April 30, 2008

Re: Draft North Coast Instream Flow Policy

**A Critical Review of the December 2007 State Water
Resources Control Board Draft Policy for Maintaining
Instream Flows in Northern California Coastal Streams and
Supporting Documents**

FIGURE 8-5
Project #15: Modeled impairment at limit of anadromy with no diversion constraints
Normal water year

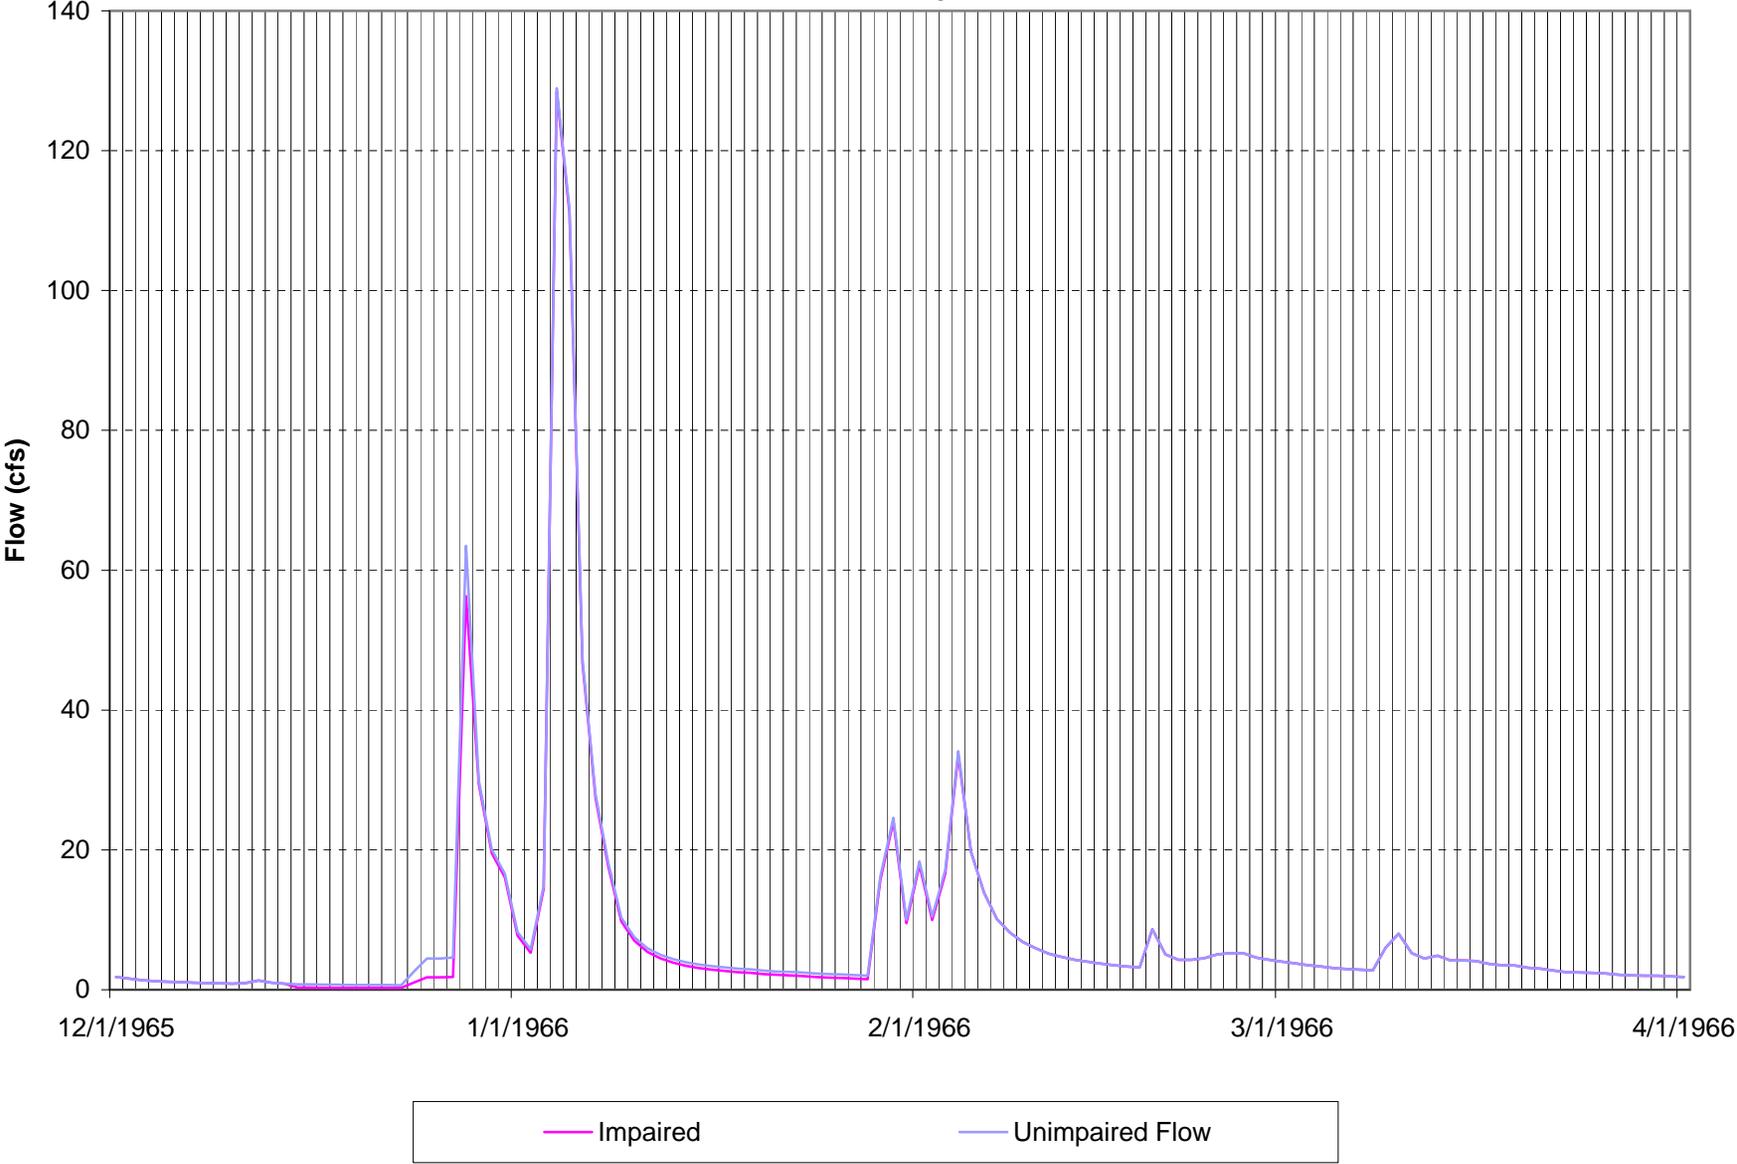
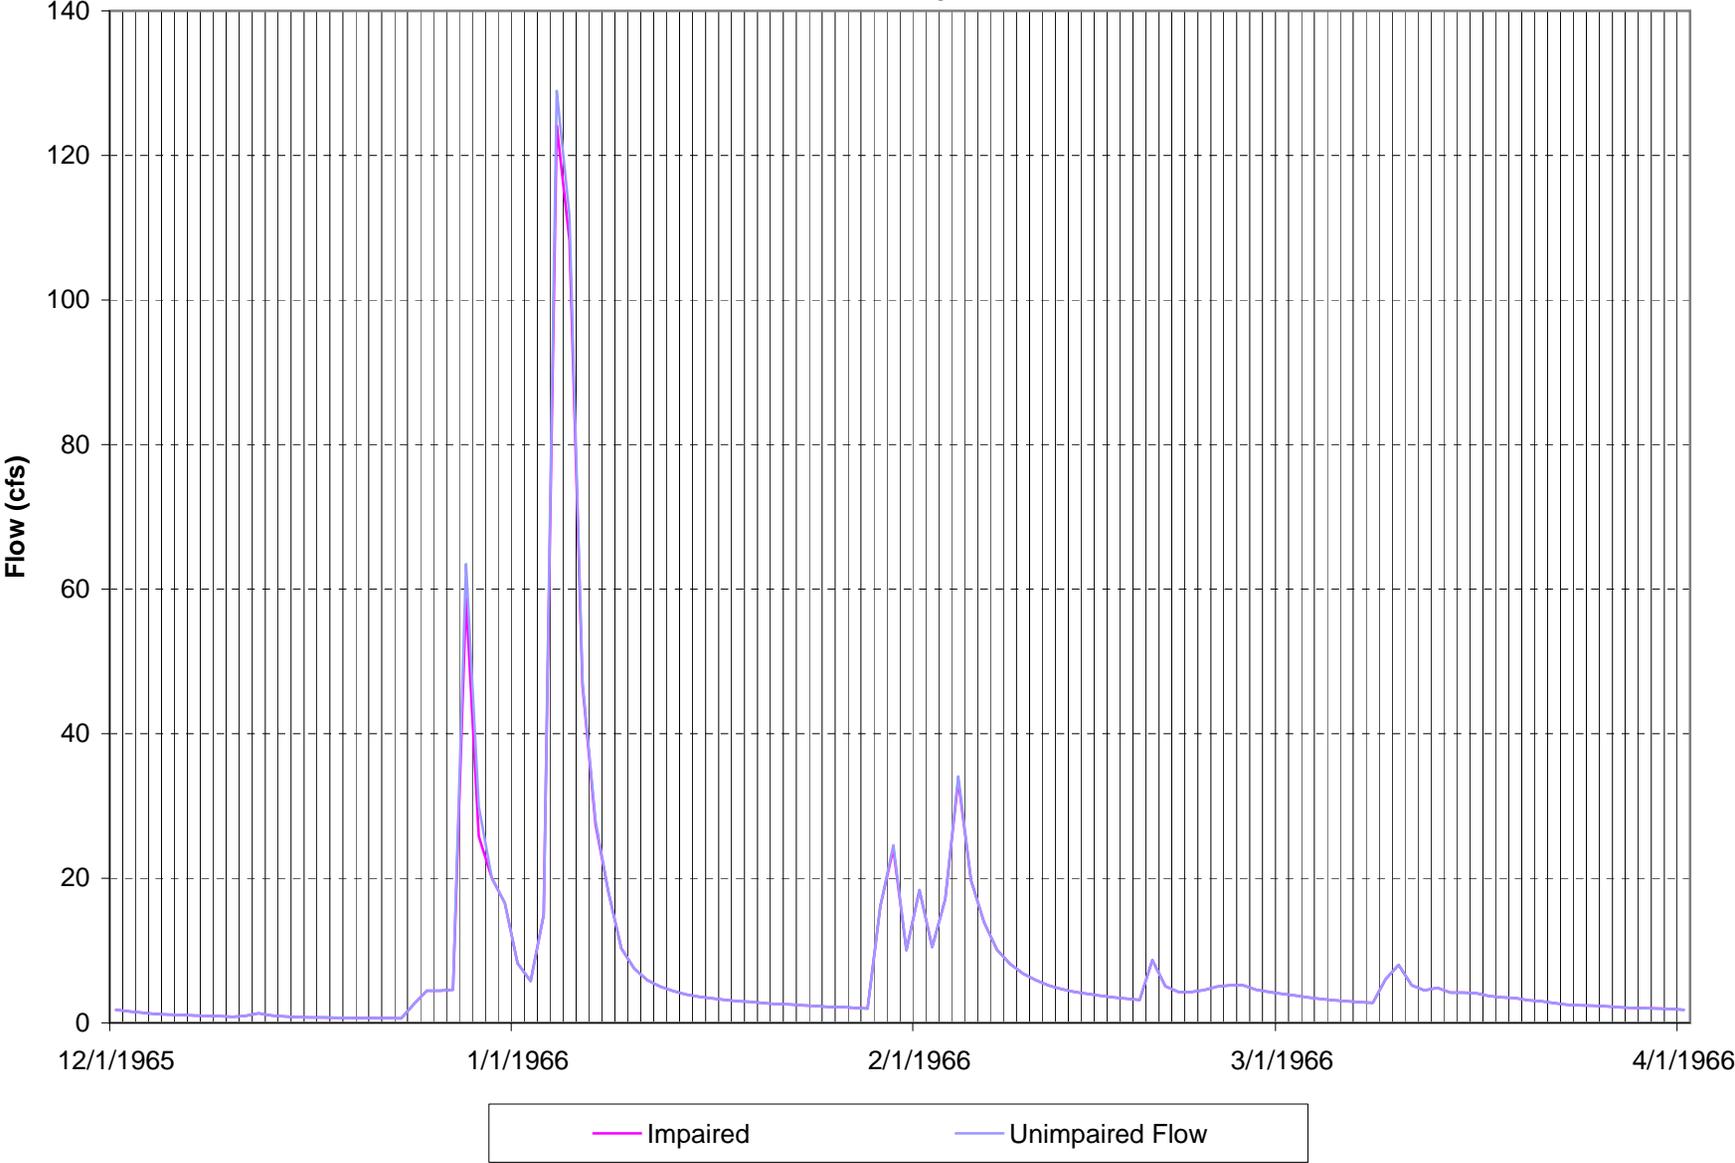
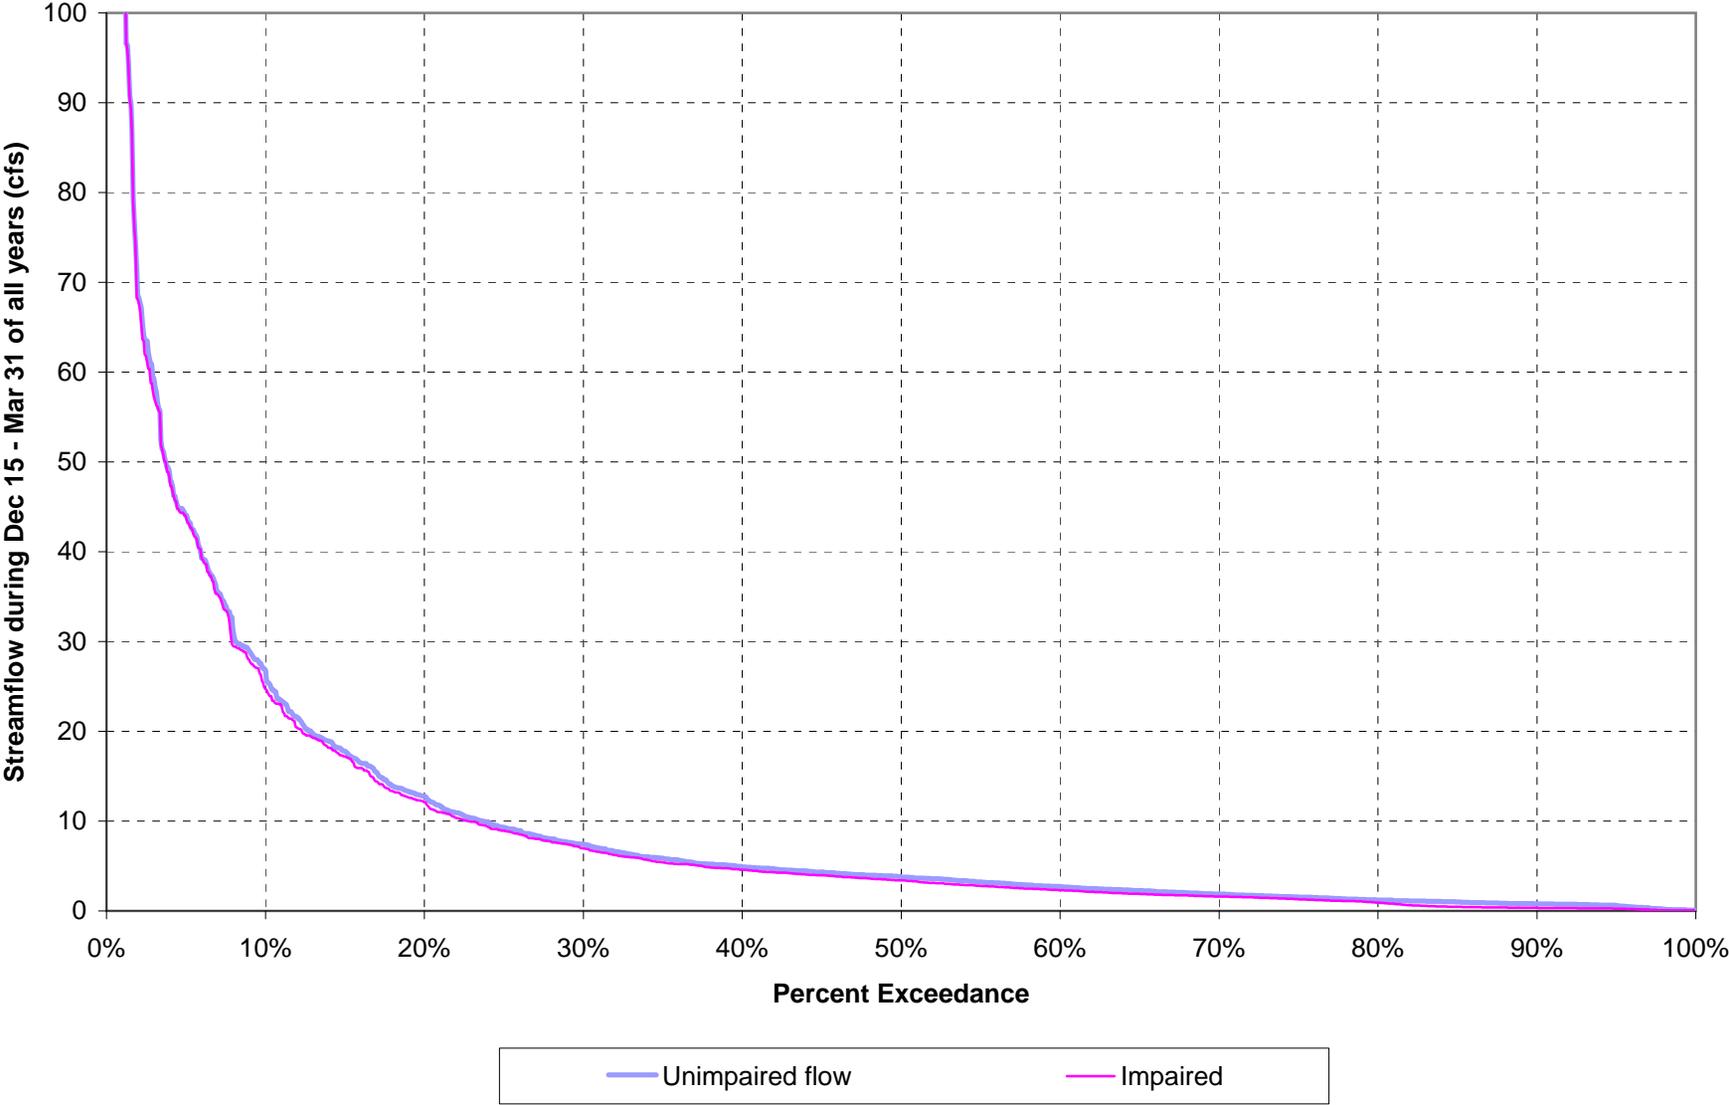
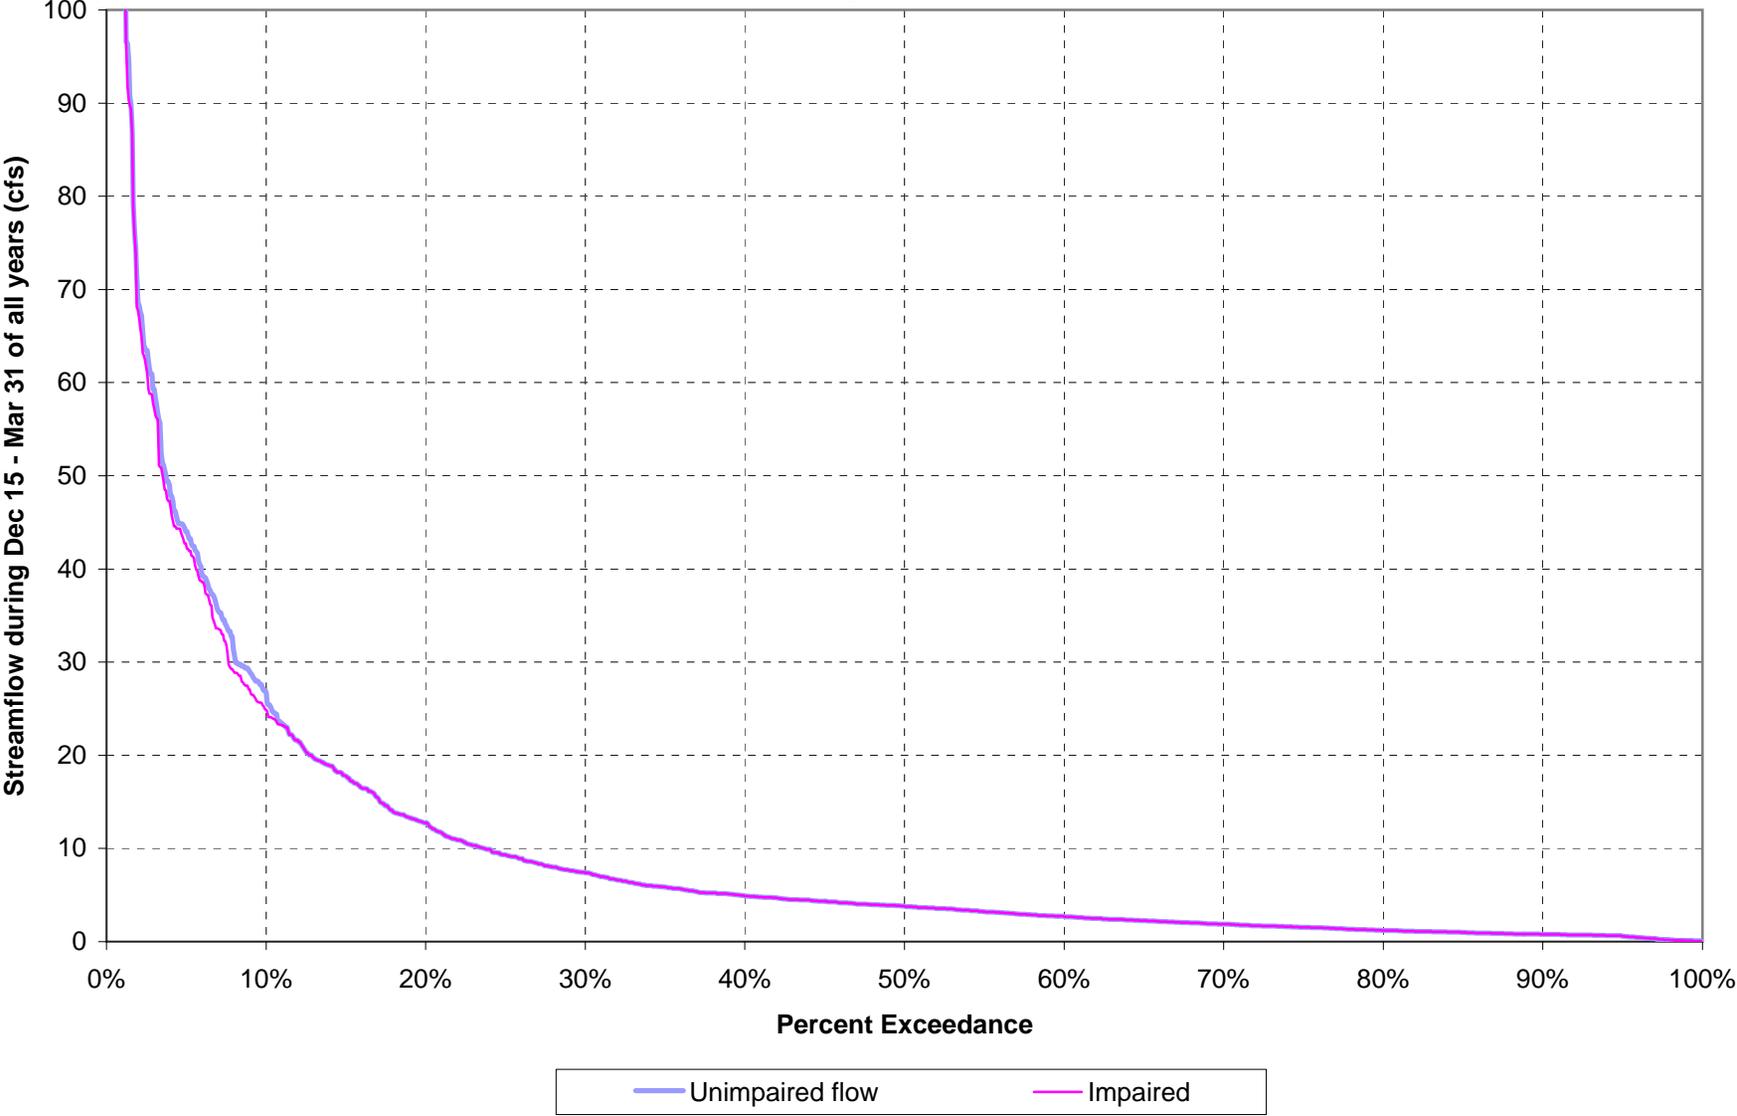
As noted above, the limit of anadromy is located about one mile downstream of Project #15. Figures 8-5 through 8-8 (attached) provide information at the limit of anadromy. These hydrographs and exceedance curves show the impact of the project is minimal. One has to look closely at Figure 8-7 to see that at lower flow rates the red line (impaired flow) is below the blue line (unimpaired flow), whereas, in Figure 8-8 at lower flow rates, the red line and blue line are coincident. This amount of change is less than the order of accuracy in estimating impacts.

These hydrographs show the project, when diverting without constraint, creates minimal effect on streamflows. However, the Draft Policy would restrict allowable diversions and result in the project yield being cut to less than half.

FIGURE 8-11
Project #5: Modeled impairment at POD under Policy
Normal water year (Project yield this year = 15 AF)

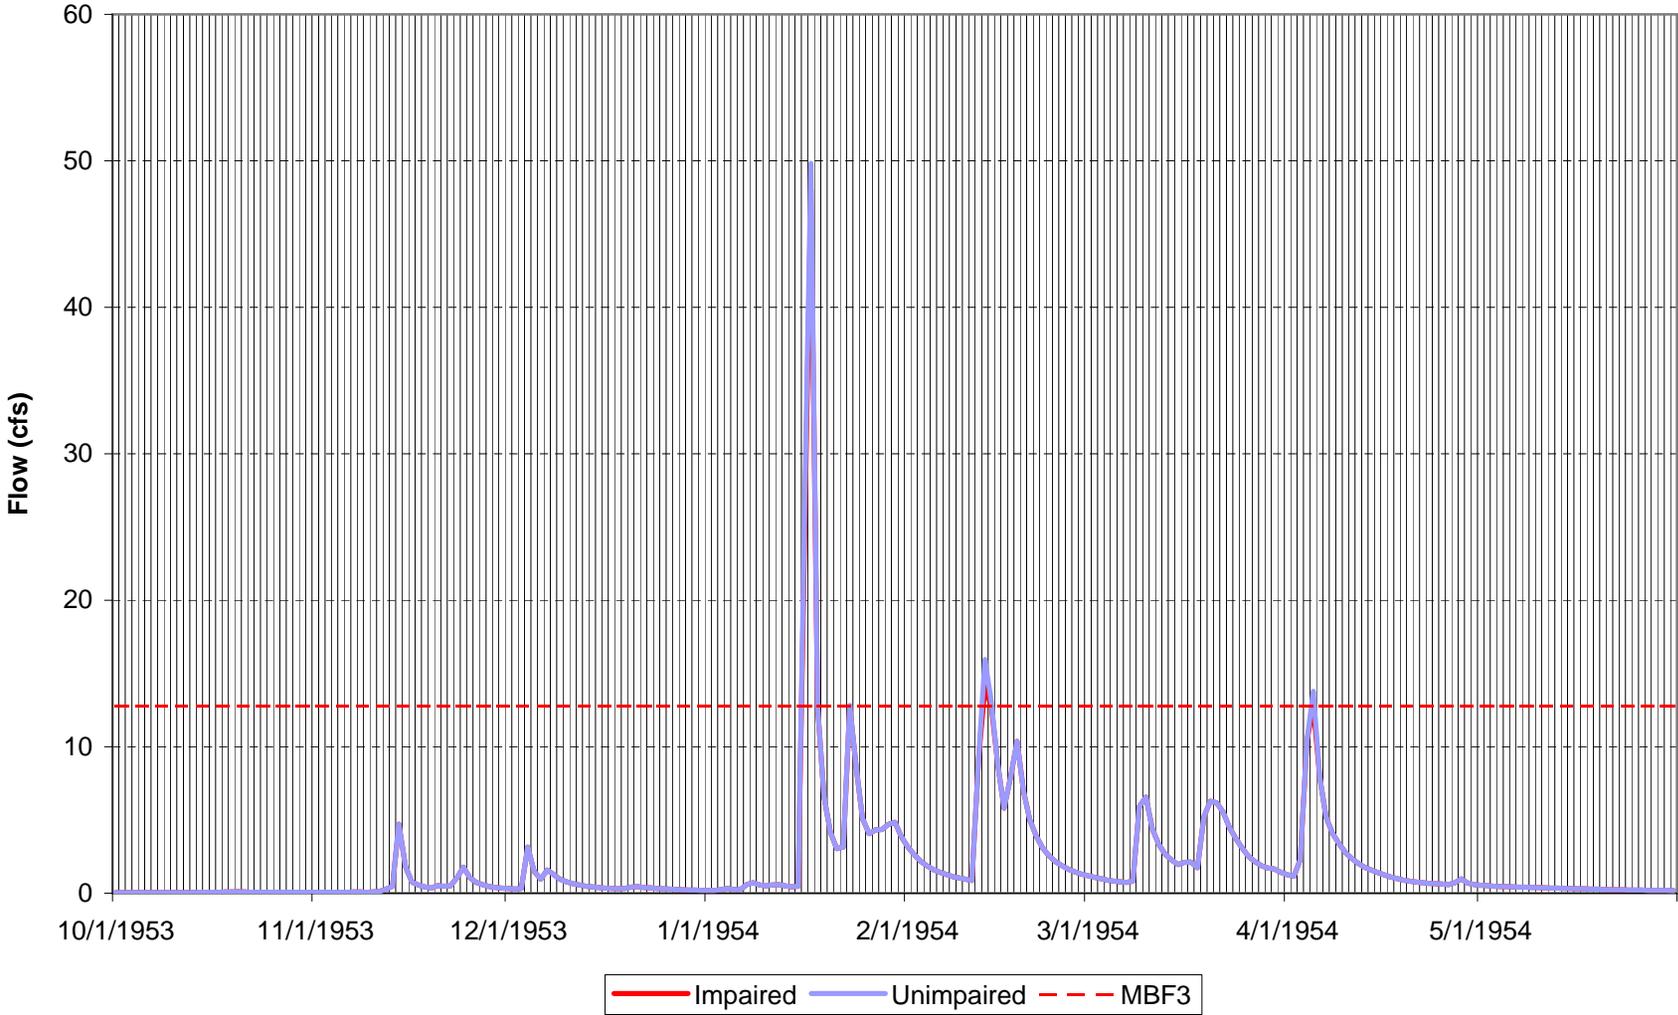
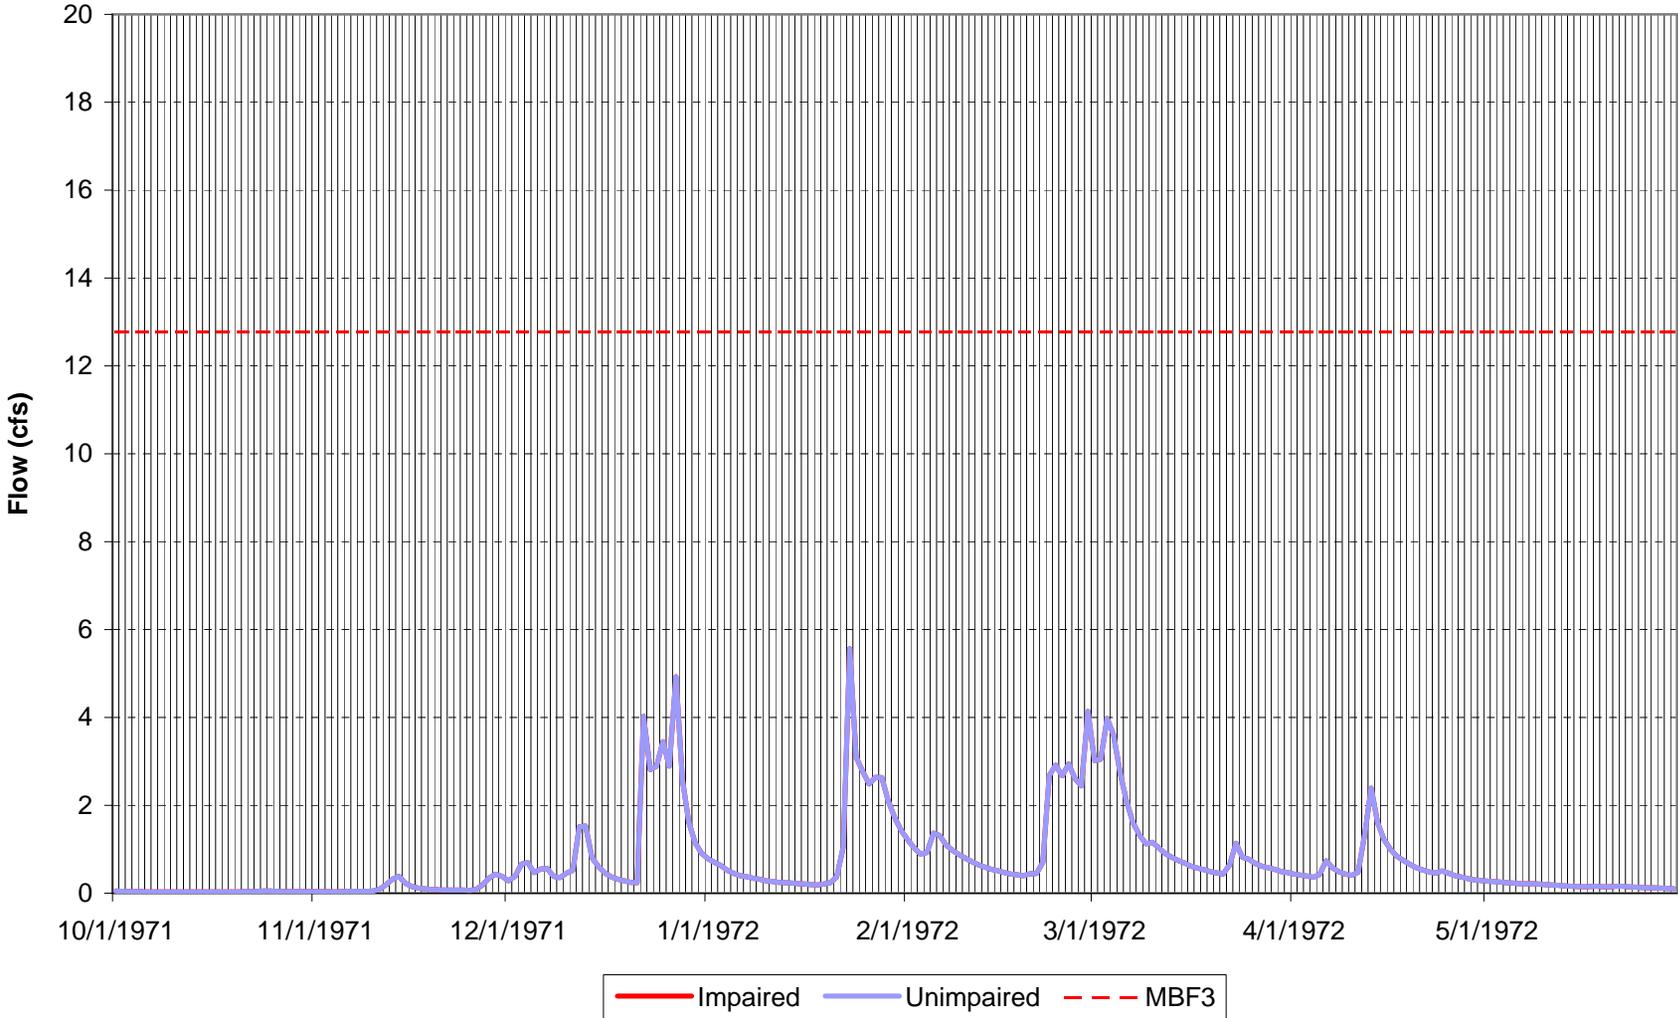
Figures 8-11 and 8-12 (attached) show streamflows immediately below the POD under the proposed Policy scenario. Also shown is the minimum bypass flow (MBF3) required at this location under the Policy. The average annual yield of this Project under the Policy would be cut approximately in half, to 16 AF.
